Response to Information Request

Development Application for Material Change of Use – Multiple Dwelling (4 Units)

65 Stagpole Street, West End and formally identified as Lot 3 on SP338397

Information Request

STP CONSULTANTS	
Client T & R AKINYEMI	
Project Details MULTI-RESIDENTIAL DEVELOPMENT 65 STAGPOLE STREET WEST END QLD 4810	
Drawing Title VEHICLE TURNING PATH VISITOR GARAGE TURNING PATHS	
Job No. STP24-1965	Drawing No. SKC-101
Revision A	Date 13.07.26
CIVIL

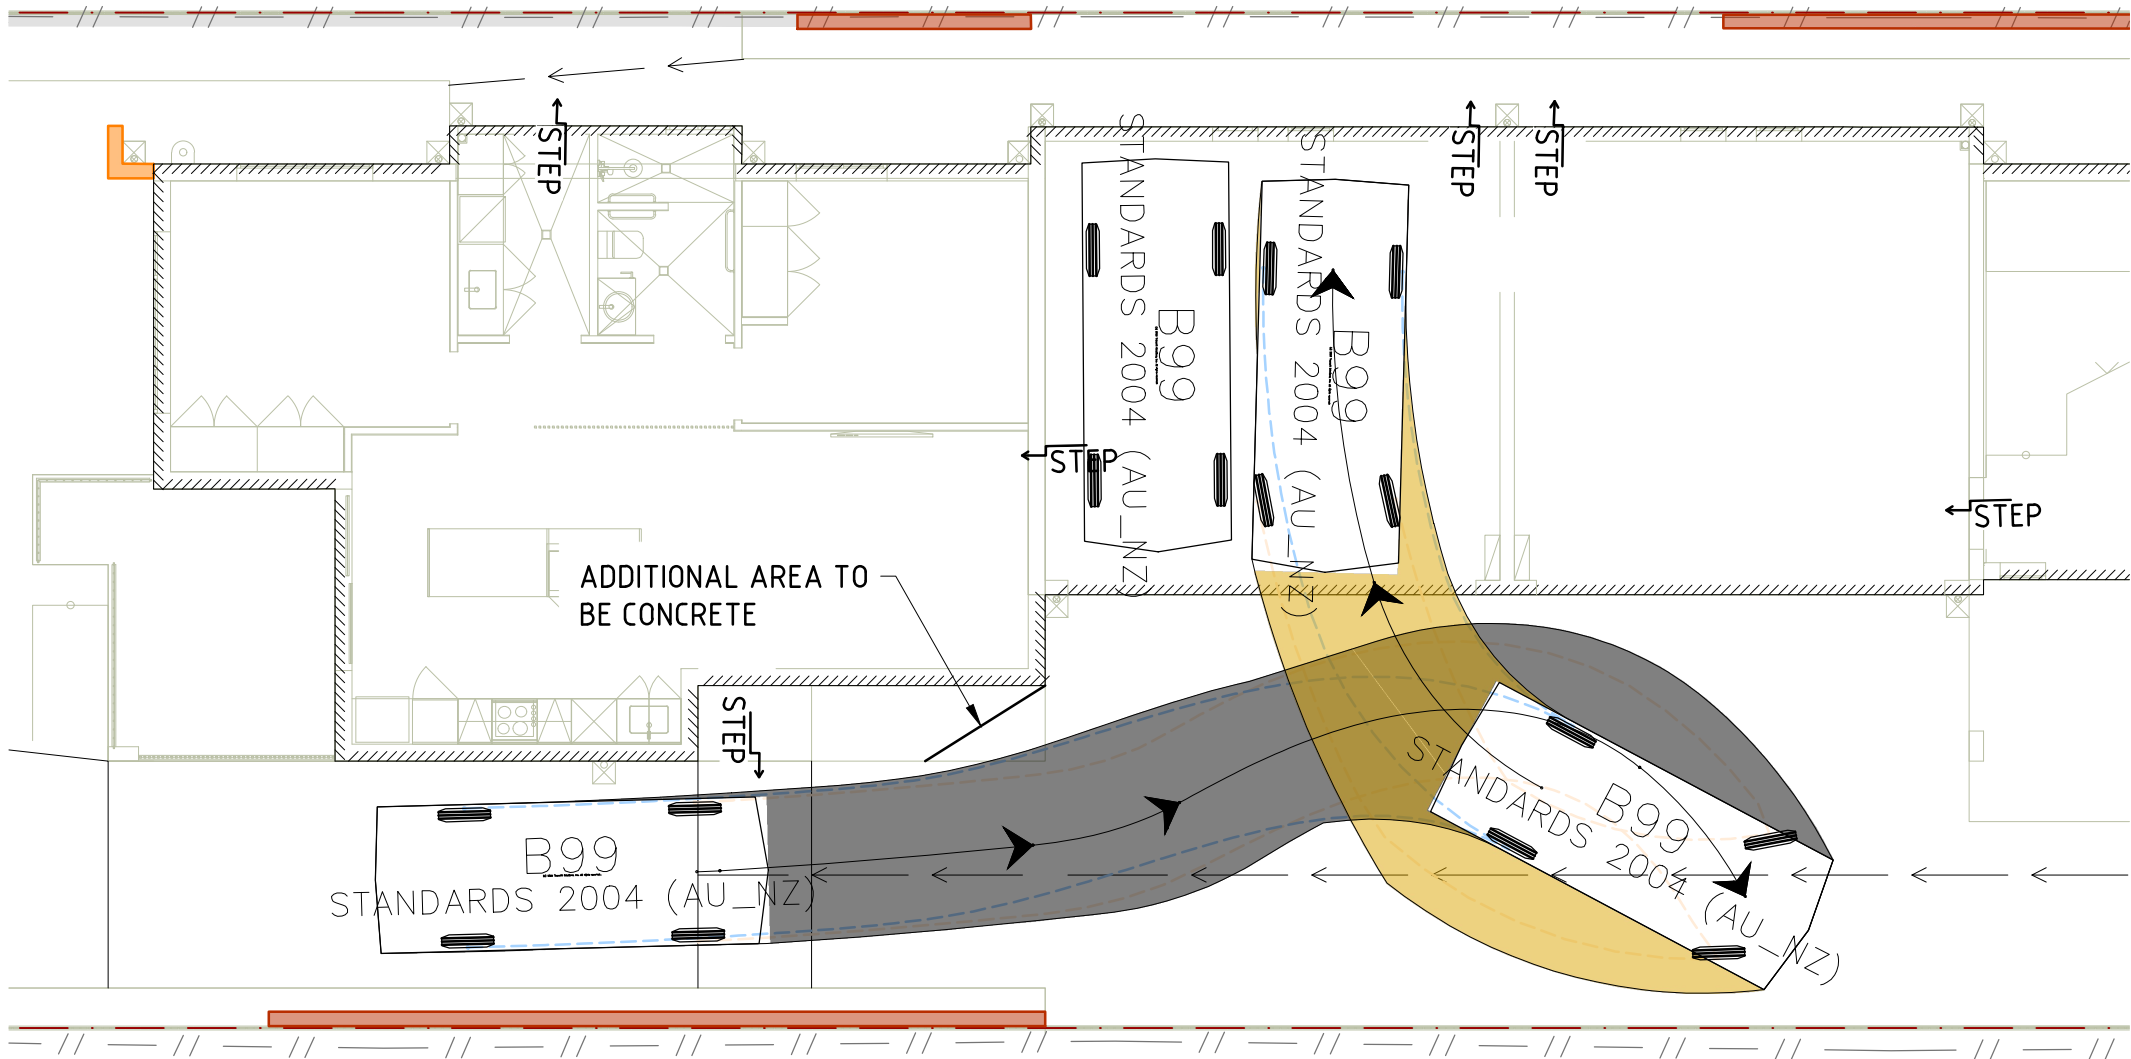
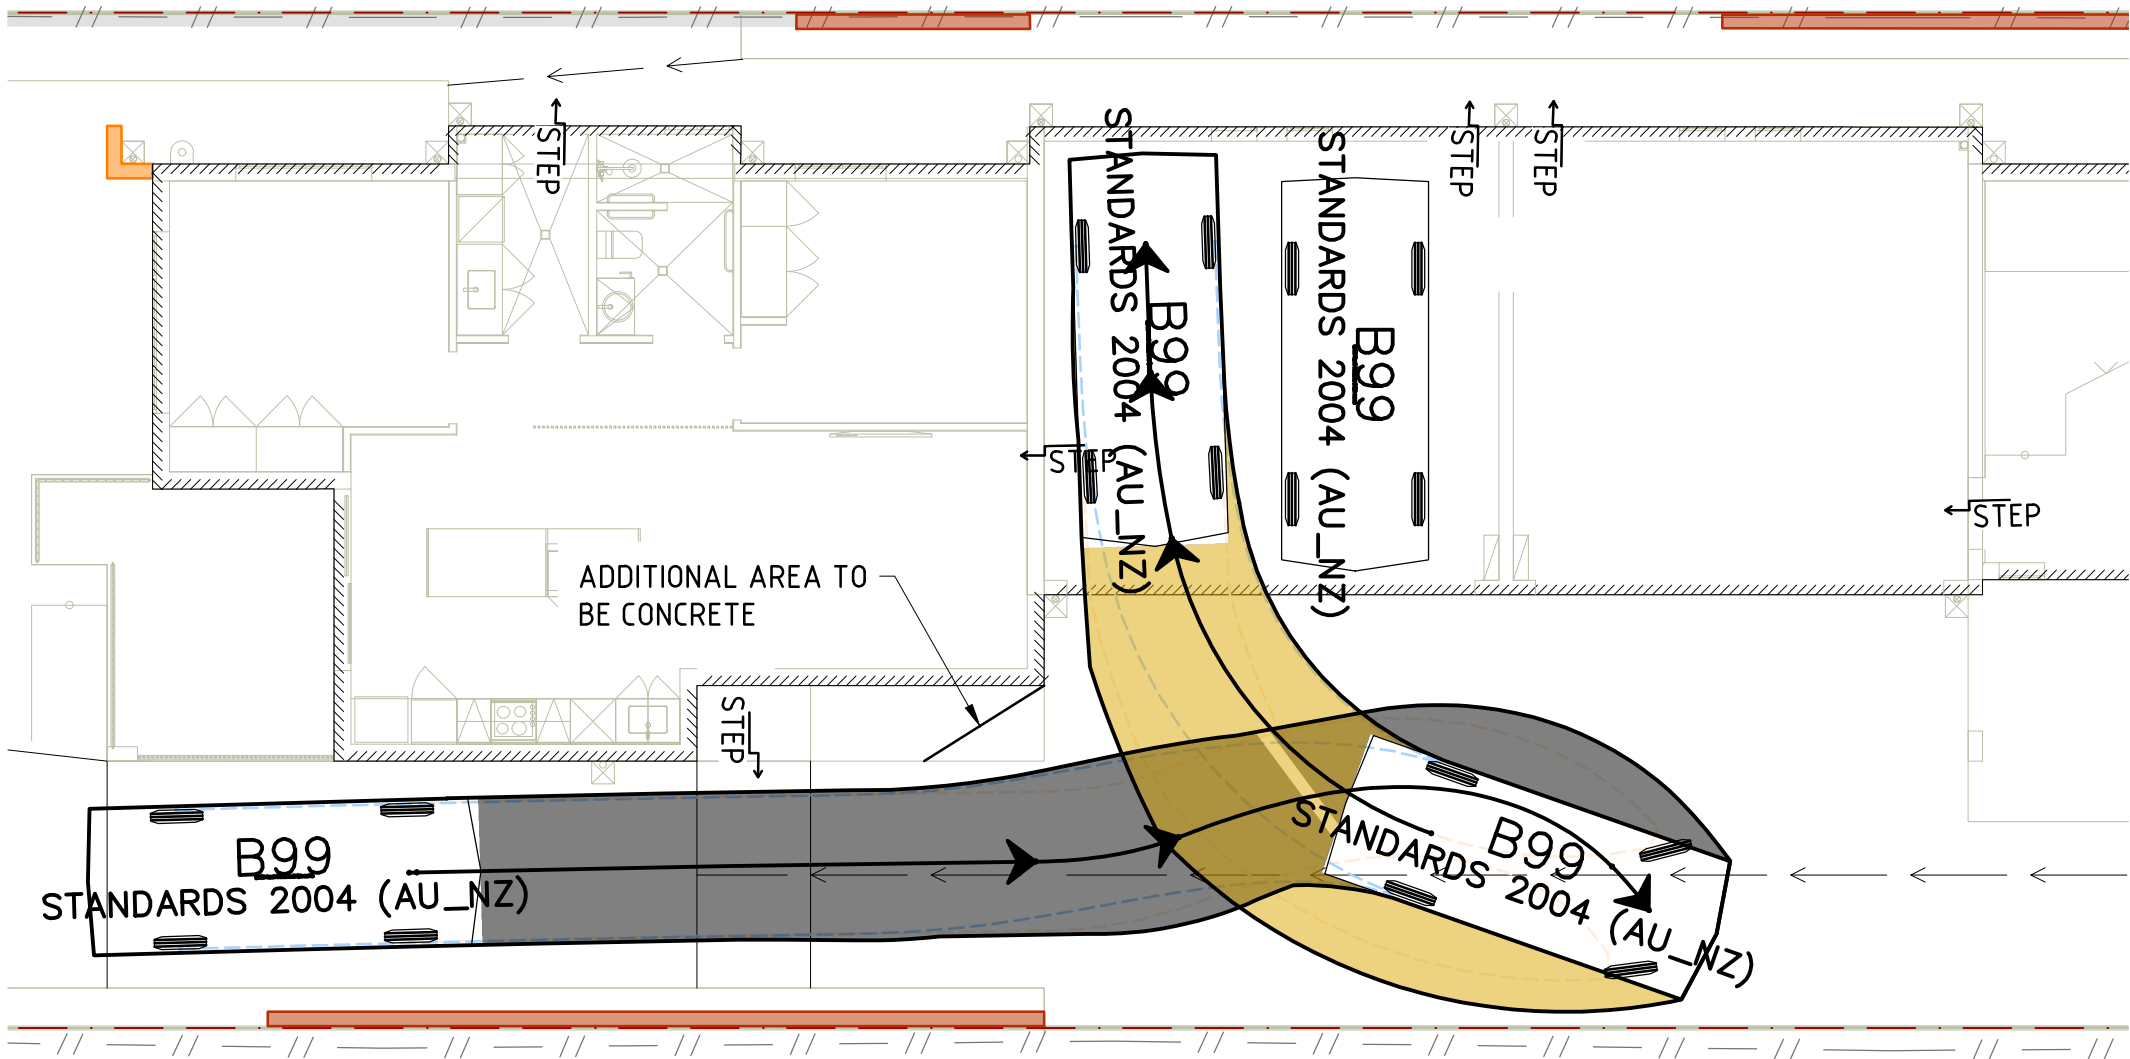
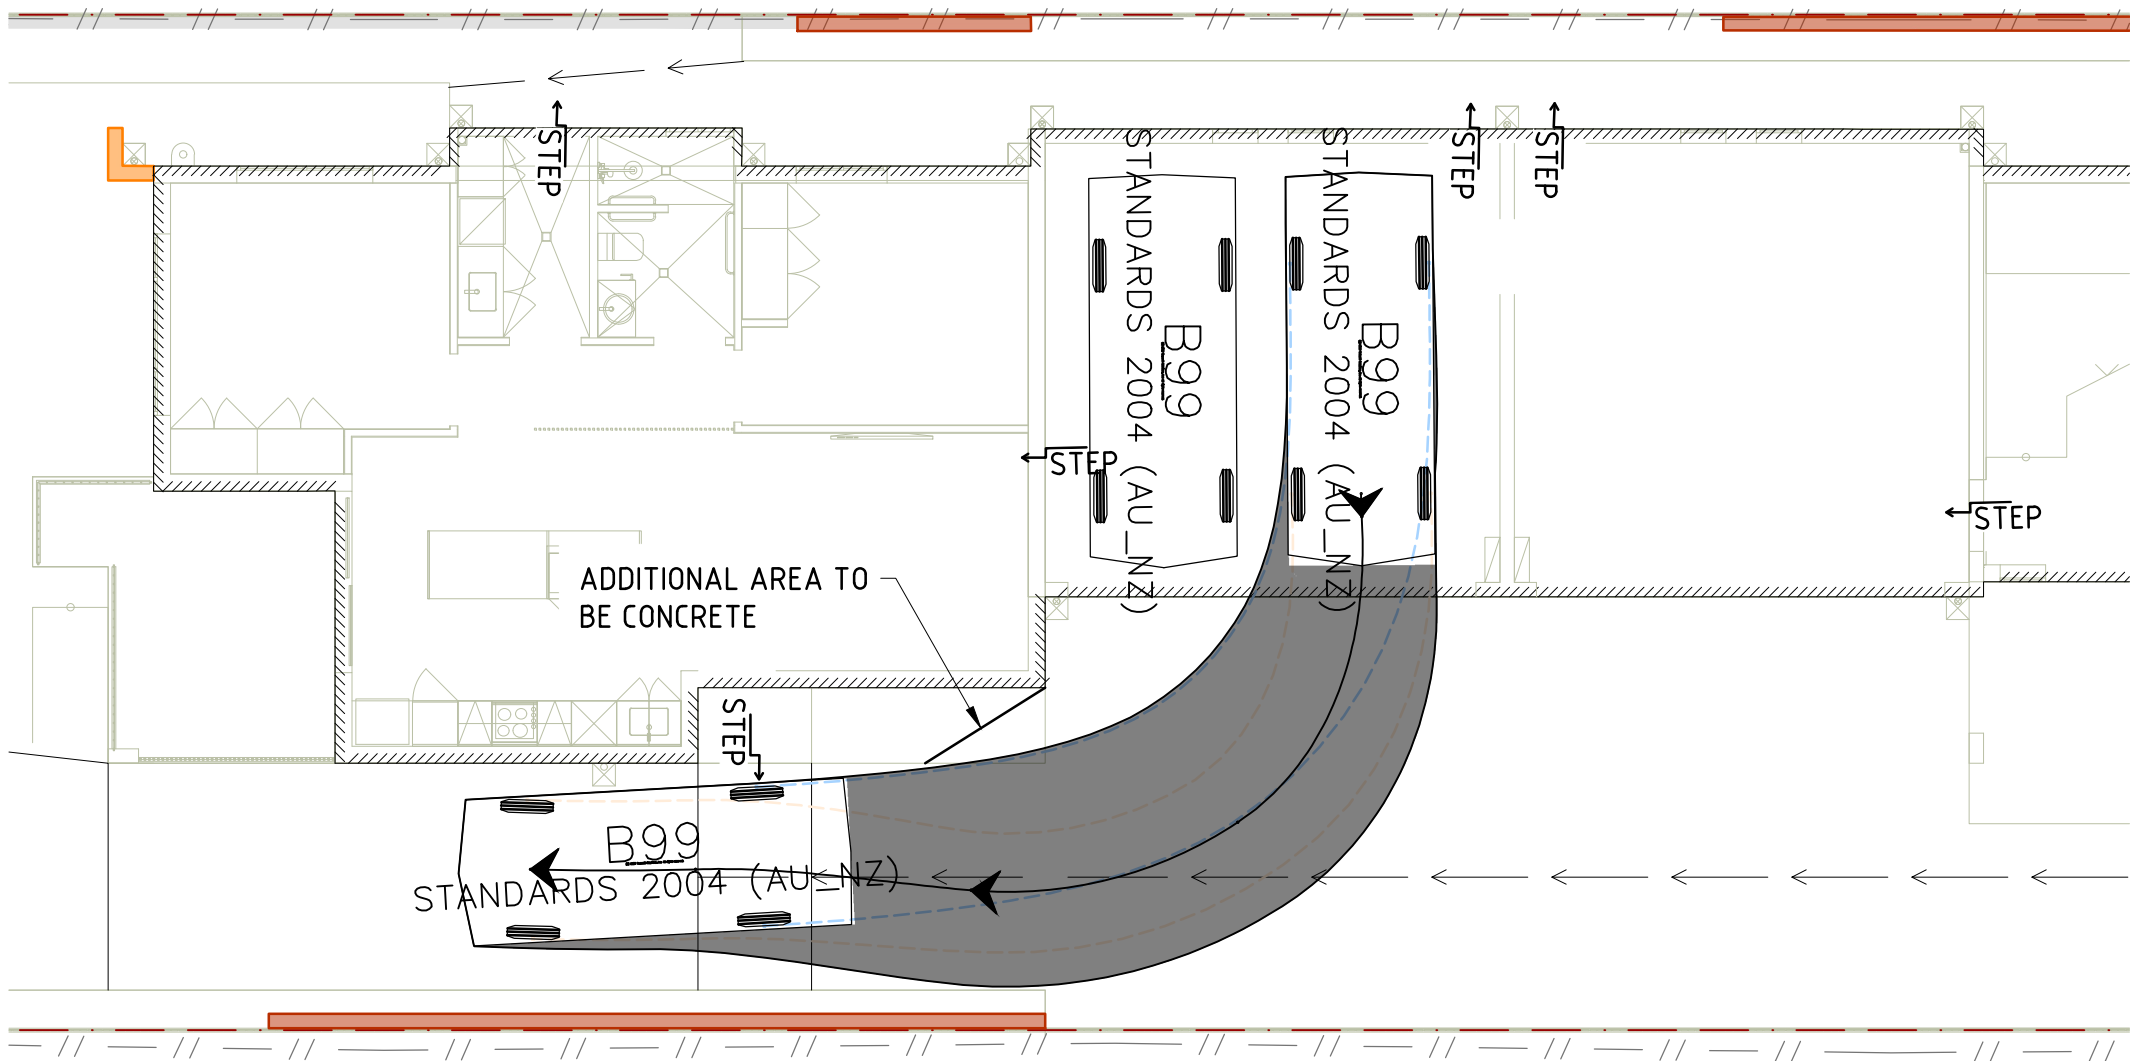
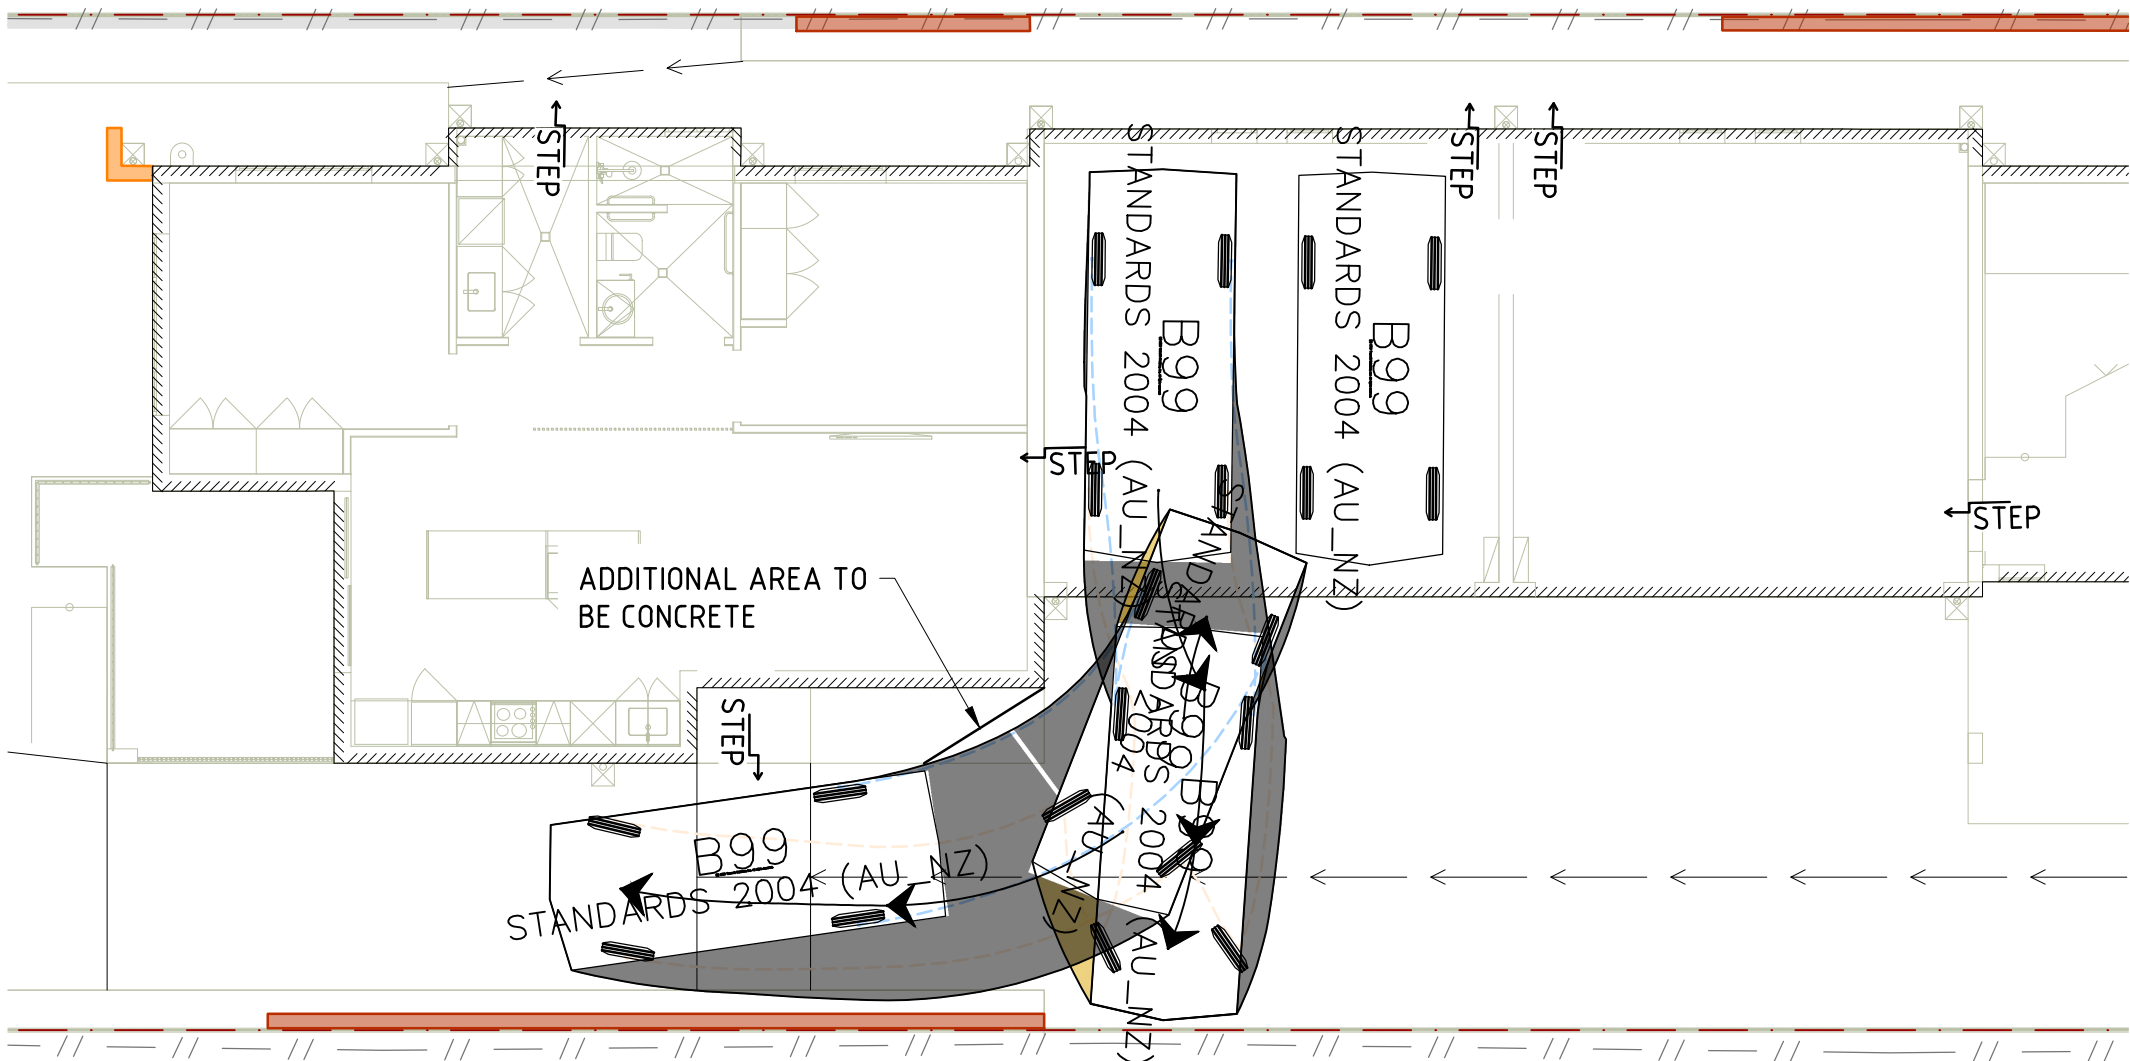
The exit motion appears to be restricted for vehicles exiting carpark 1, 4 and the visitor and possibly obstructed by the porch access and the garden located on unit 1 external wall.

In response to this item, please find vehicle swept path plans prepared by STP Consultants at **Attachment 3**. It is considered the provided plans suitably demonstrate that passenger vehicles can efficiently and safely enter and exit the site and manoeuvre within the proposed internal carparking areas.
